Zion Nuclear Power Station, Units 1 and 2  
Facility Operating License Nos. DPR-39 and DPR-48  
NRC Docket Nos. 50-295 and 50-304

Subject: Submittal of Defueled Safety Analysis Report Update, Revision 5  
Report of Changes, Tests and Experiments

**ZION NUCLEAR POWER STATION  
DEFUELED SAFETY ANALYSIS REPORT REVISION 5**

Figure 3-42

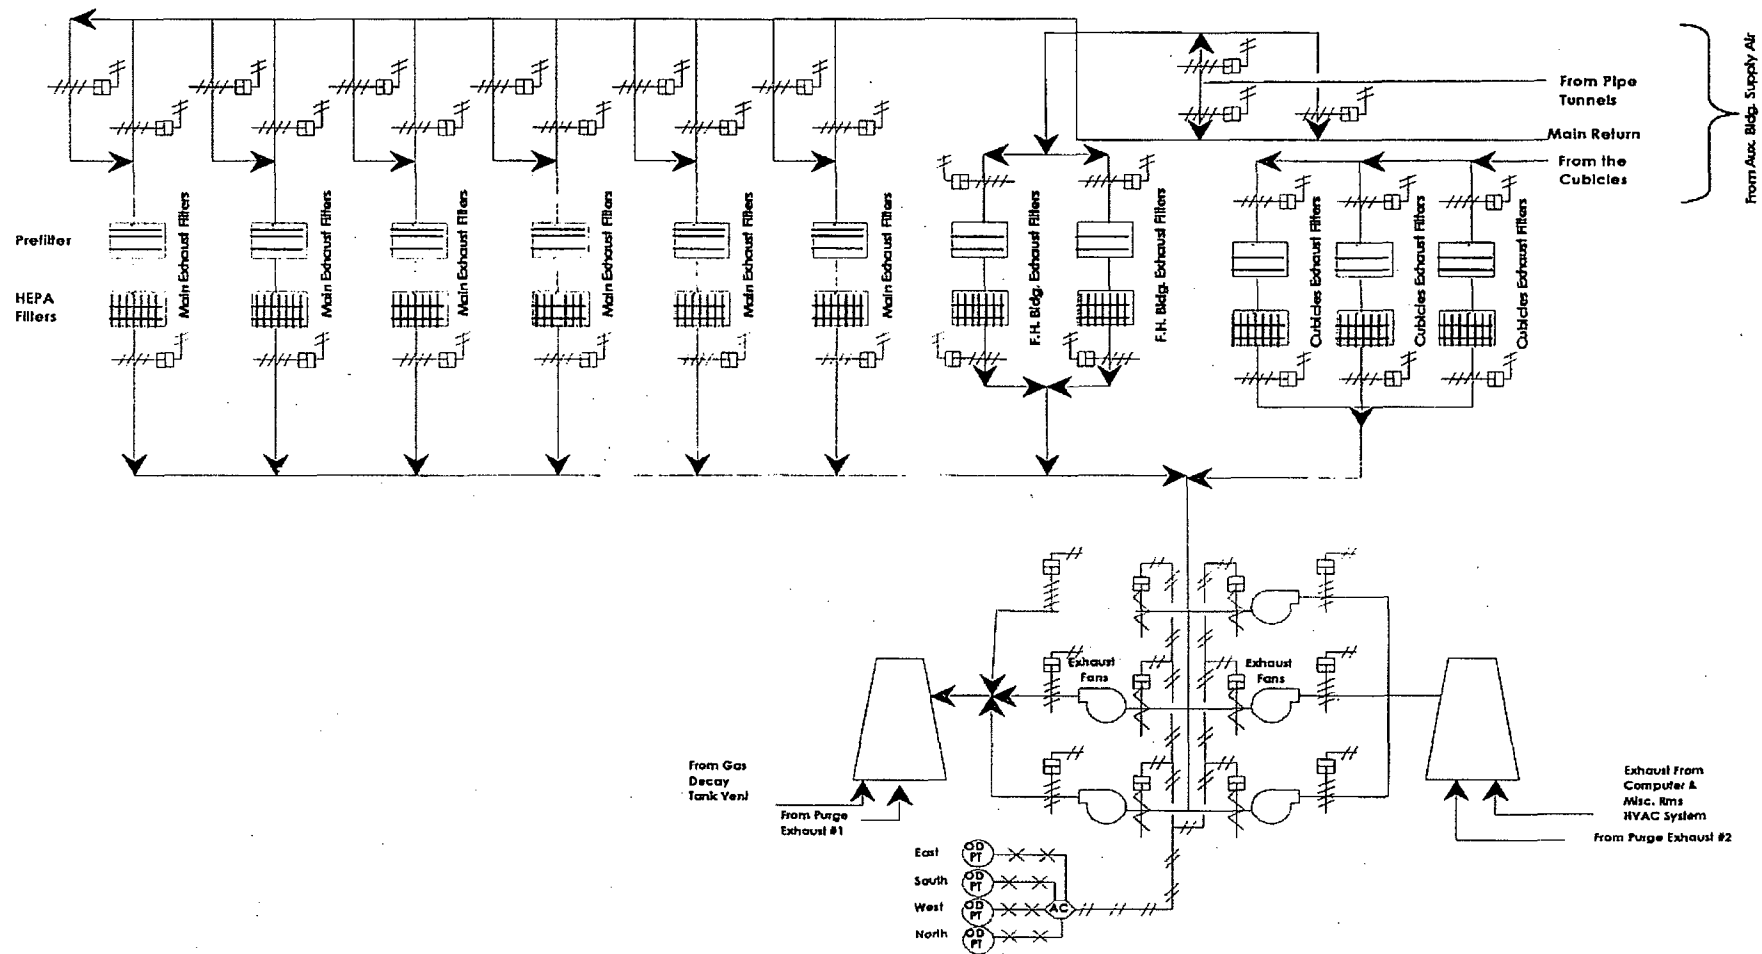
<b>Pages</b>	<b>Description of Change</b>
Figure 3-42	Delete one Auxiliary Building exhaust fan. The fan has been permanently removed from the plant.
Pages 4-11, 4-13, 4-14, 4-16	Eliminate references to the Radiation Monitor Display System (RMDS). The RMDS system is no longer in use.
Page 6-5	Delete obsolete references associated with the Quality Assurance Topical Report.
